Burlington Conservation Board

Conservation Board Meeting Public Notice

April 5, 2021 at 5:30 PM

Conservation Board Meeting Minutes

Building 32 - Elevated Deck

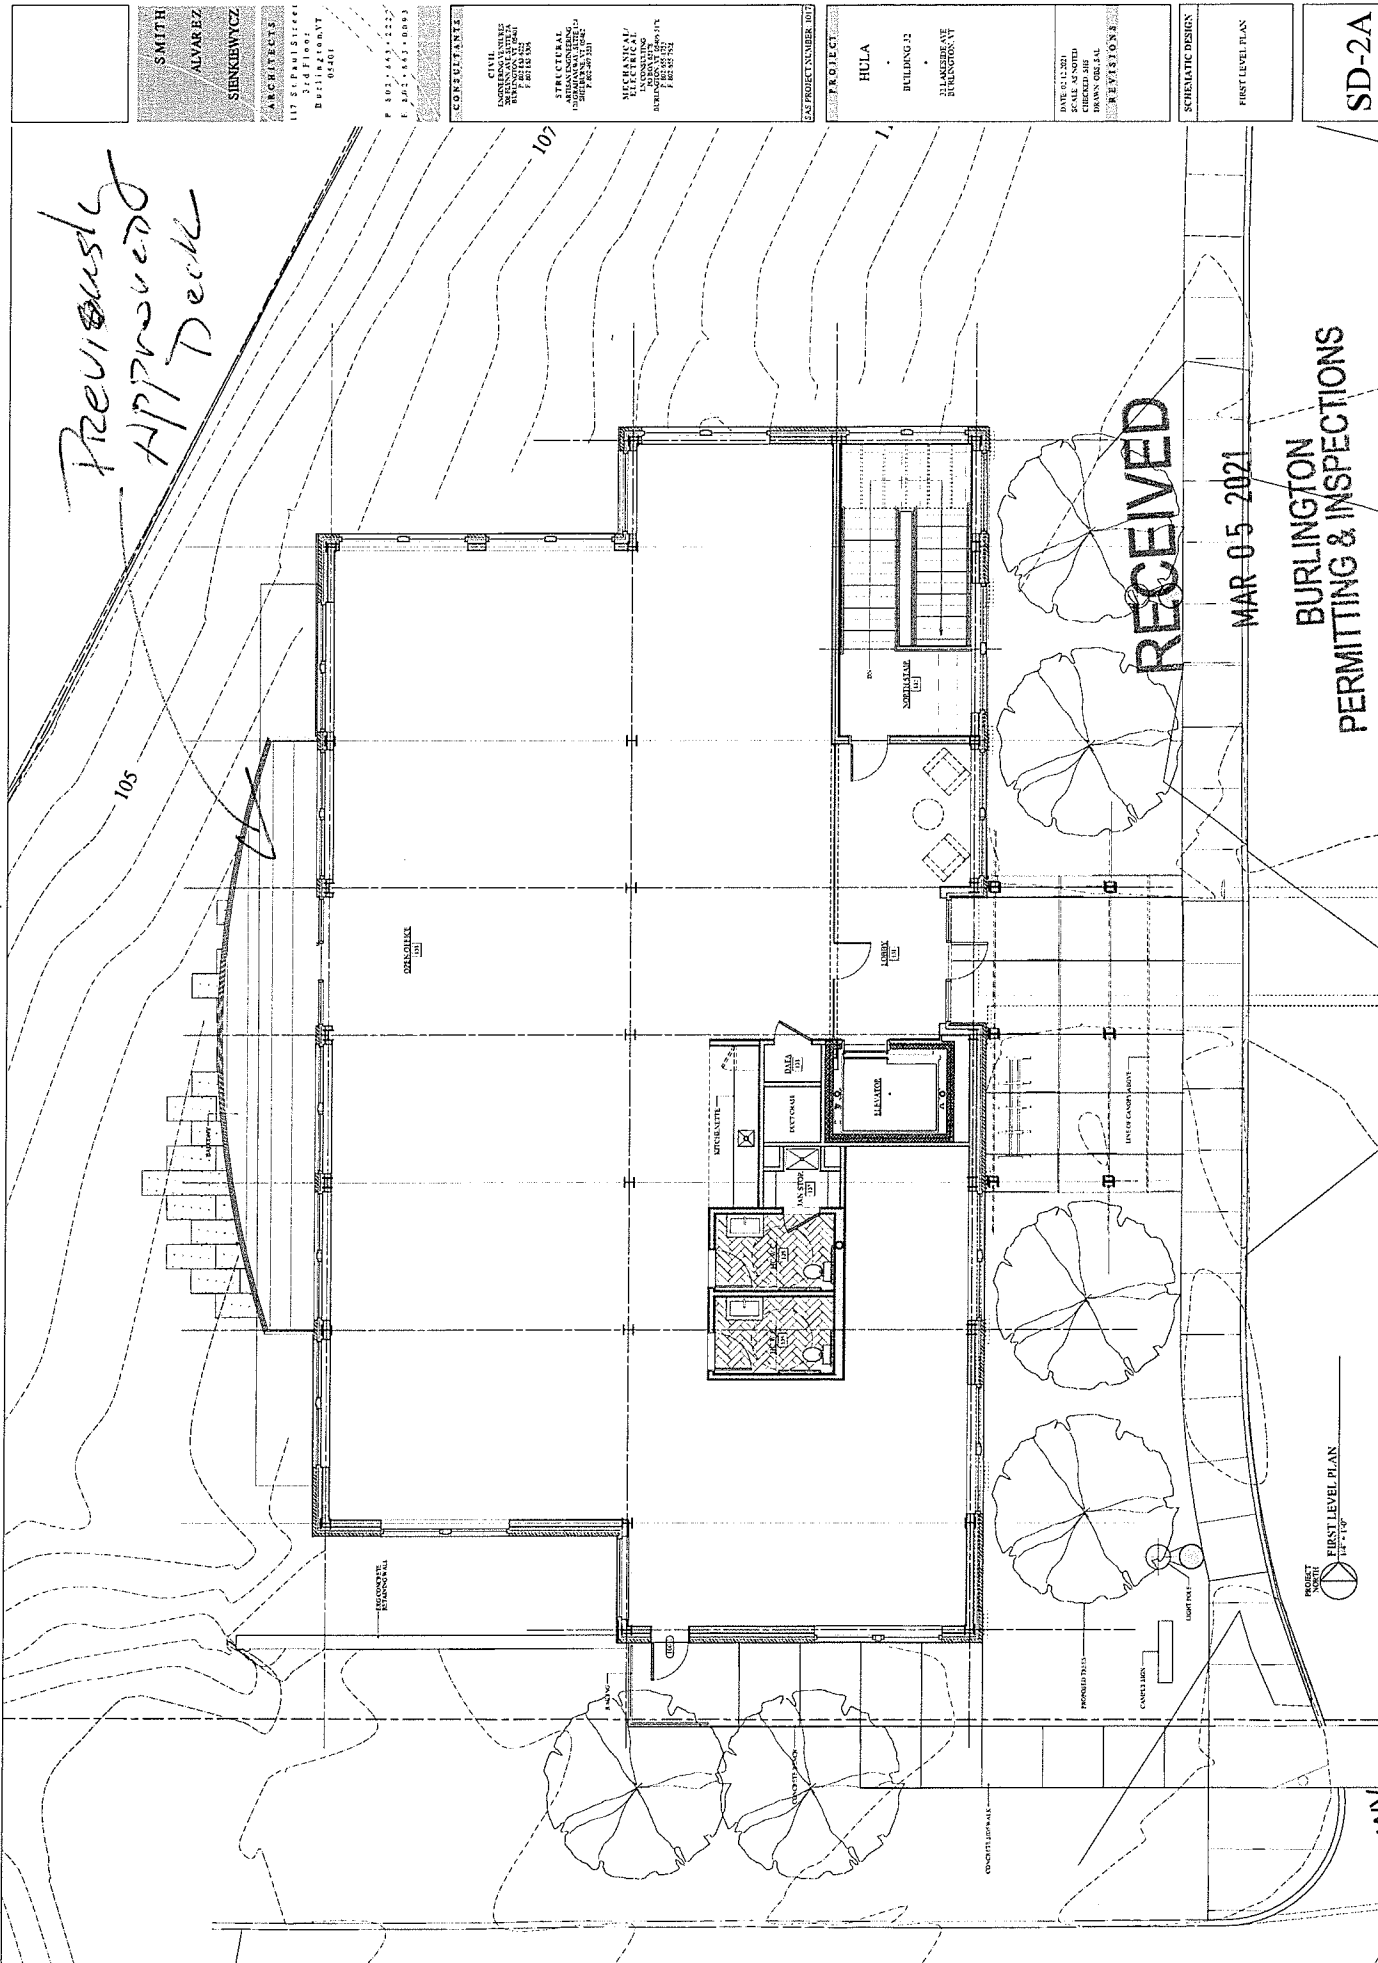
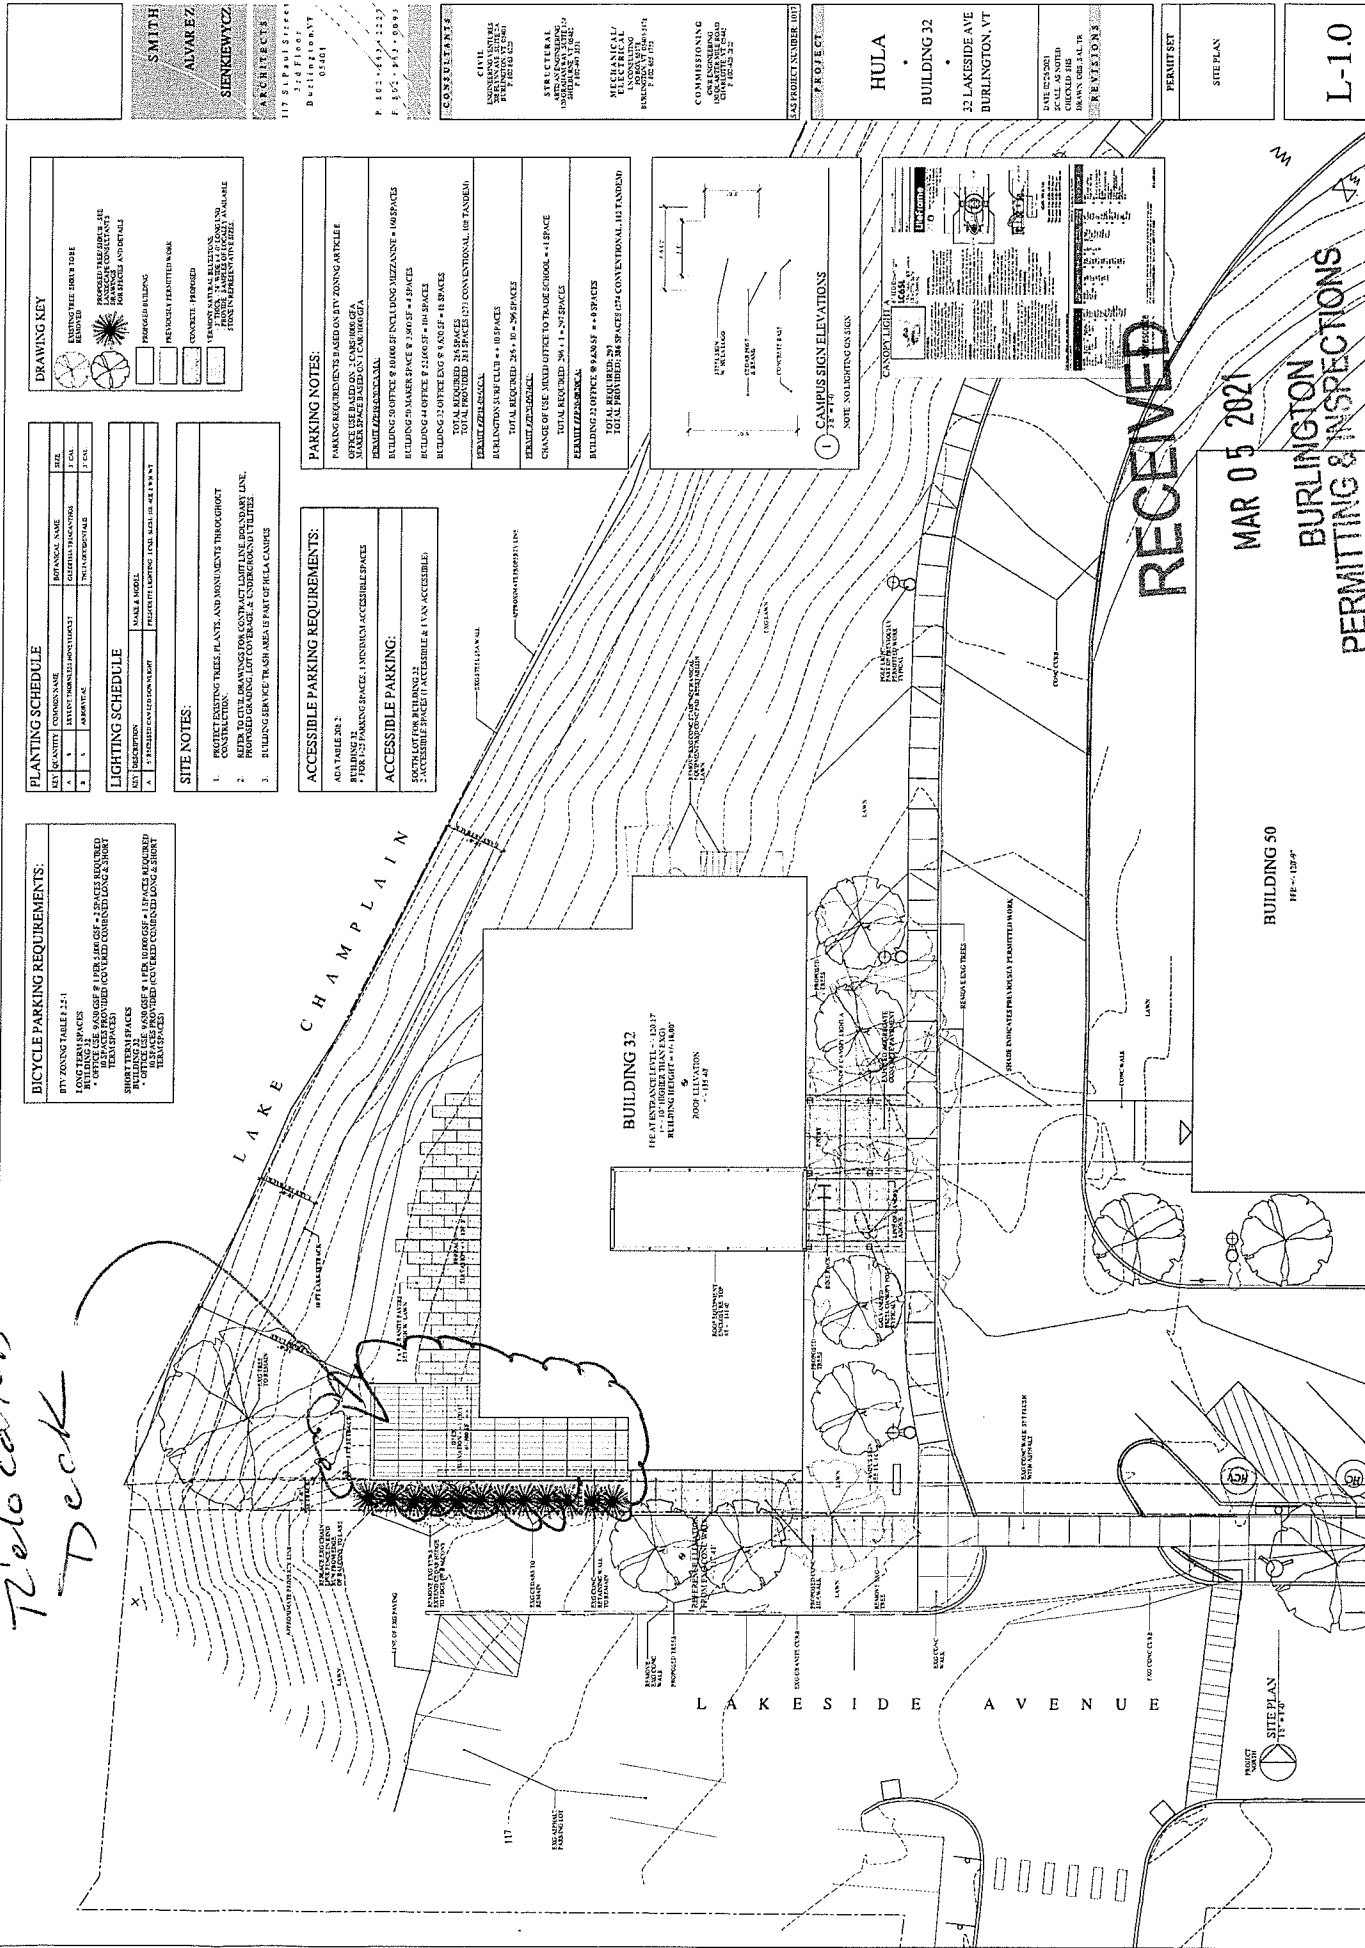
Mr. Caulo said that one more structure – a yurt – is proposed. It will have no foundation, like the others. There is also a bath house building that's not depicted on this site plan (it was previously approved). The yurt is anticipated to be a contemplative space intended to compliment the yoga use in the area. The proposed location is within the lakeshore buffer.

MW said that the lakeshore buffer does not prevent development. It carries requirements for permit review. Some would like to see the shoreline naturalized, while others would like to provide lakeshore access. MW said the yurt doesn't seem like a big ask.

RC asked about the prior location. Mr. Caulo said that the pavers will remain, just without a deck. MW asked if the lakeshore green space will be mowed lawn. Mr. Caulo said that, through Act 250, some area along the sheet piling will be allowed to be more natural. The landscaping plan calls it out.

MW suggested that a better plan along with a site visit may be worthwhile. Mr. Caulo is willing to do this.
